AGENDA FOR THE CANTERBURY BANKSTOWN LOCAL PLANNING PANEL MEETING

ITEM 1	Application to Amend the Bankstown Local Environmental Plan 2015: 81-95 Boronia Road, Greenacre
APPLICANT	dmpps Town Planning & Property Development Services
OWNERS	GPV Investments Pty Ltd
AUTHOR	Planning

Figure 5: Proposed Concept Plan, May 2022

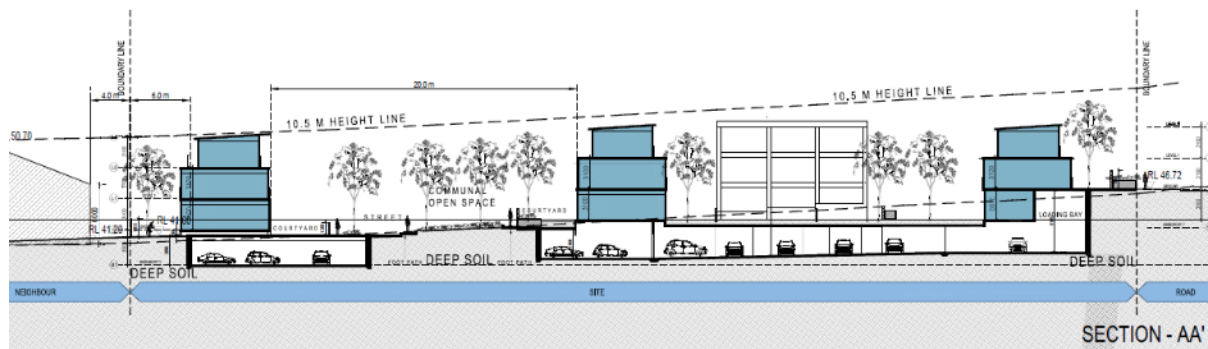
The revised application includes a concept plan for a medium density townhouse development, comprising 70 townhouses and 150 vehicles in a basement carpark accessed via a single entry/exit off Boronia Street. 20 visitor car parking spaces and the waste collection area is proposed on the ground floor, however a loading bay for waste collection is also shown in the basement.

The proposal includes a communal open space area of approximately 485m² which is approximately half the area of the communal open space offered in the initial proposal.

Figure 9: 1 in 100 Yr Flood Affection

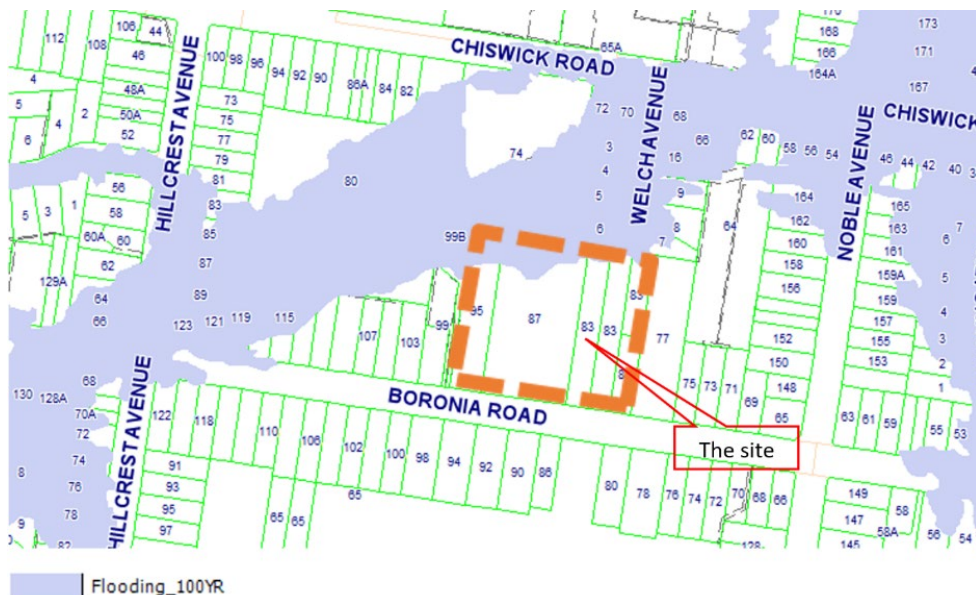
Council's review of the applicant's flooding assessment confirm that the proposal does not provide an acceptable assessment of flood impacts and flood risks consistent with the requirements of the Flood Risk Management Guide LU01 (DPE, 2022) (FIRA). The proposal does not consider potential risks associated with flooding, proportionate to the intensification being proposed on the site, except for a recommendation that the dwellings are to be elevated above the flood level. Further consideration of the flooding implications from enclosed spaces which may cause blockage and subsequent obstruction to flooding would be required.

The proposal does not provide information on whether there is a change in flood level/depth, flood velocities and flood hazard for multiple scenarios including but not limited to 1% AEP (100 year ARI) and Probable Maximum Flood (PMF) flooding. Additionally, the proposal has not included a management plan for evacuation in the event of a flood.

Figure 13: Urban Design Peer Review 2021 recommendation - Option 1

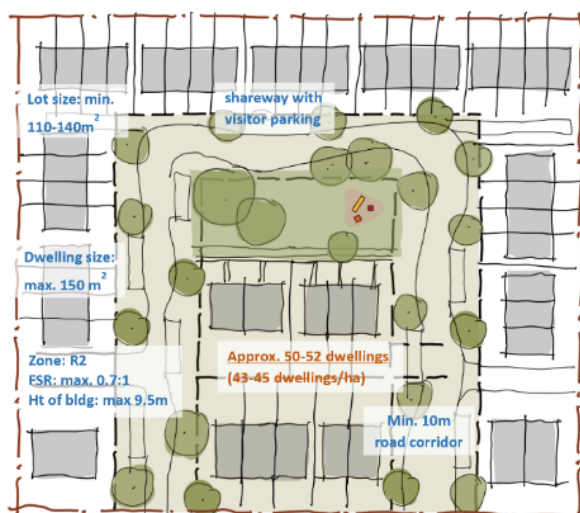
The Urban Design Peer Review tested alternative concept schemes, based on site principles developed by the independent urban design specialist. This resulted in a maximum permissible FSR of 0.7:1 for the site. According to the peer review, the FSR of 0.7:1 will enable the proposal to have an appropriate density that is compatible with the adjacent R2 Low Density Residential zoned land. The urban design specialist tested the following two alternative schemes (Figures 13 and 14), which provide a potential yield of approximately 50-52 dwellings (43-45 dwellings/ha, Option 1) and 45-50 dwellings (39-44 dwellings/ha, Option 2).

Figure 15: Complying scheme for a duplex under the Bankstown LEP 2015 (Urban Design Peer Review, September 2021)

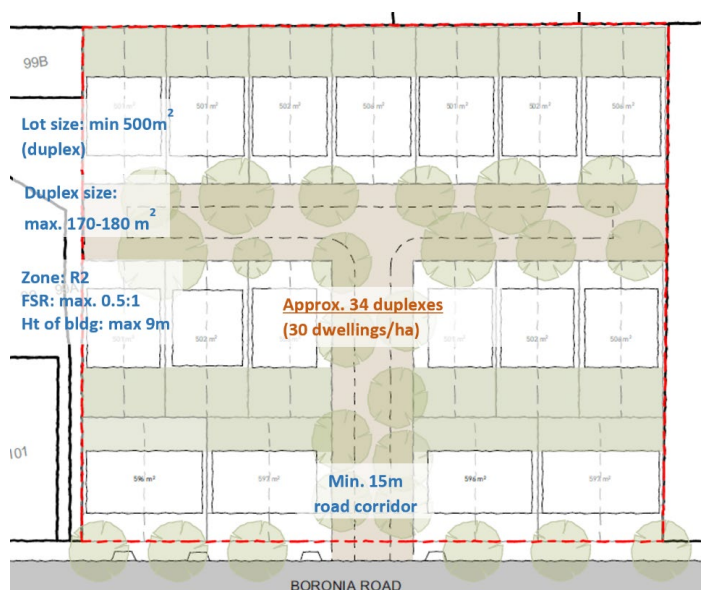
The Urban Design Peer Review also included a concept scheme for a currently permissible development involving attached dual occupancy dwellings under the existing LEP controls (Figure 15). A density of around 30 dwellings/ha (approximately 34 duplexes, 2 storeys) is currently permissible without requiring any changes to existing LEP controls.
